Brookhaven National Laboratory
Plant Engineering - E&CS Division
Engineering Change Notice Form

PROJECT: CCWF II **JOB No.** 11705

ECN Title: Tunnel Sump Pit Steel **ECN No.** 25

Affected Documents: SC-102

102B PIT COVER FRAMING PLAN (EL 64'-0")

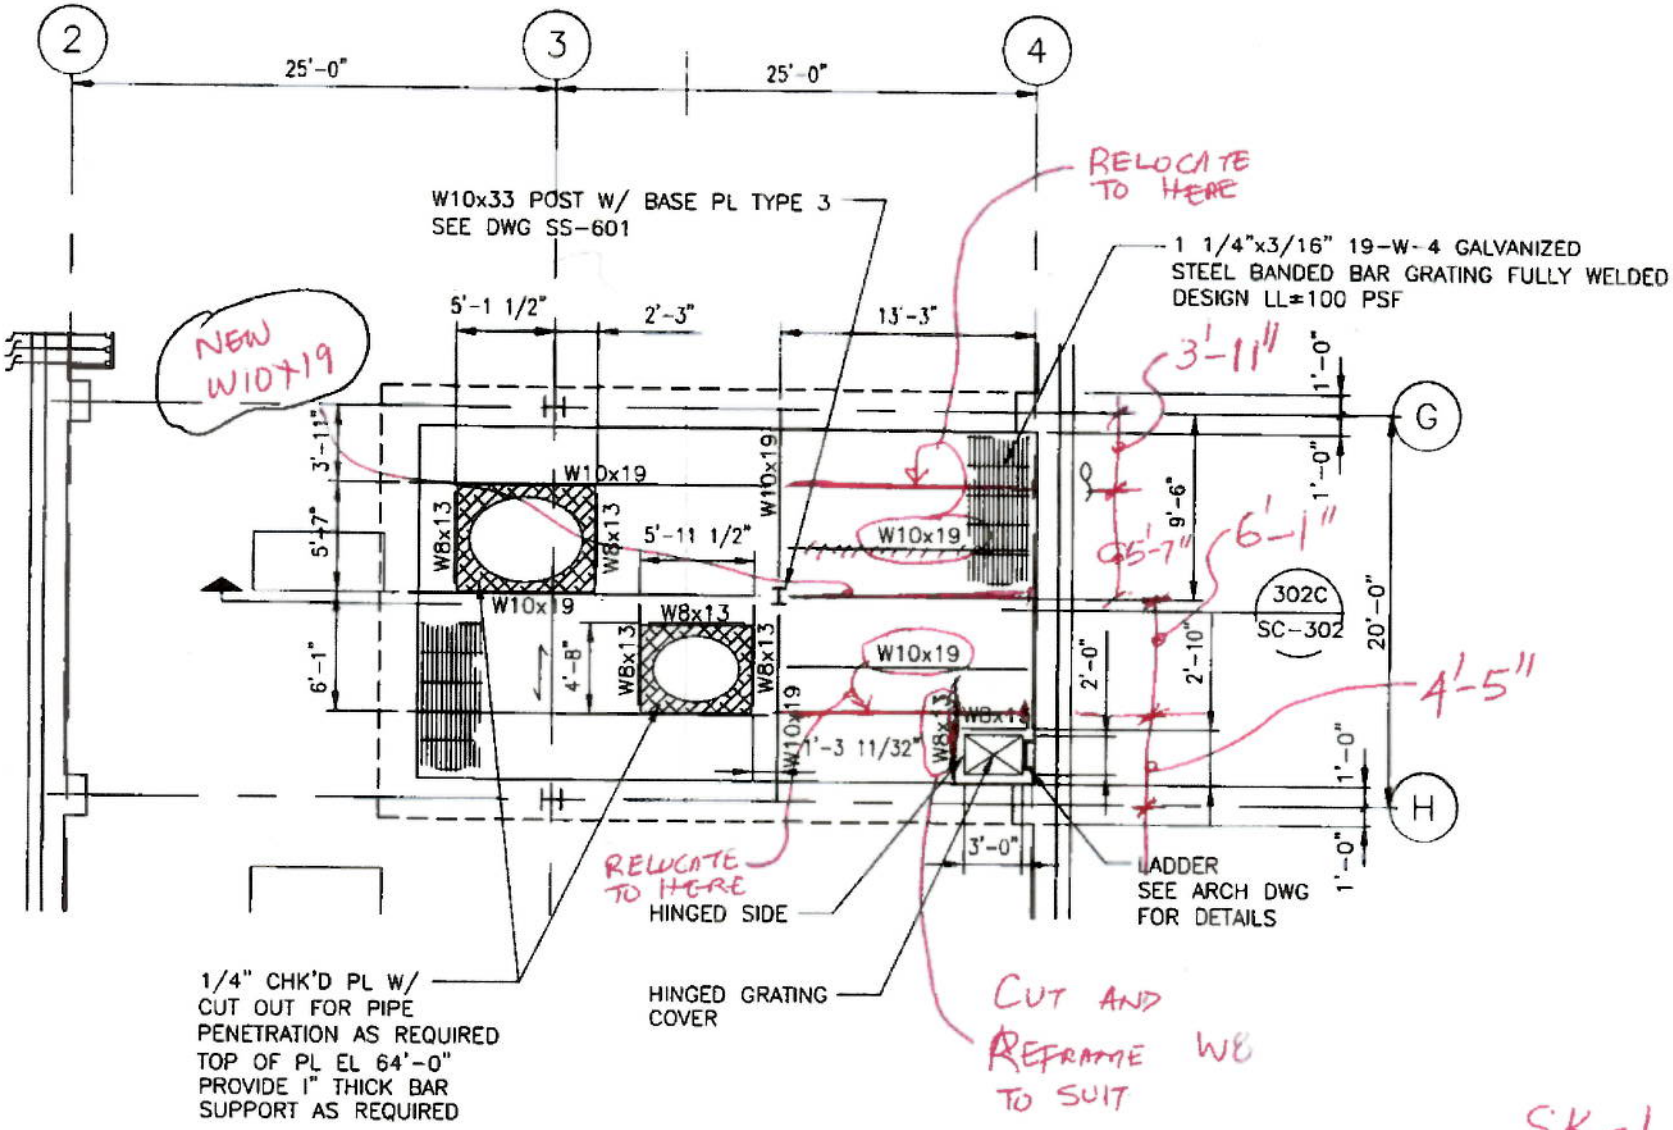
Requested Change (Attach sketch if applicable): Relocate (2) W10x19's include all appropriate anchorage due to the valves being in the way. Provide (1) New W10x19 beam. Cut and reframe W8x13 steel around ladder as per attached sketch, SK-1

Resolution: See the attached sketch.
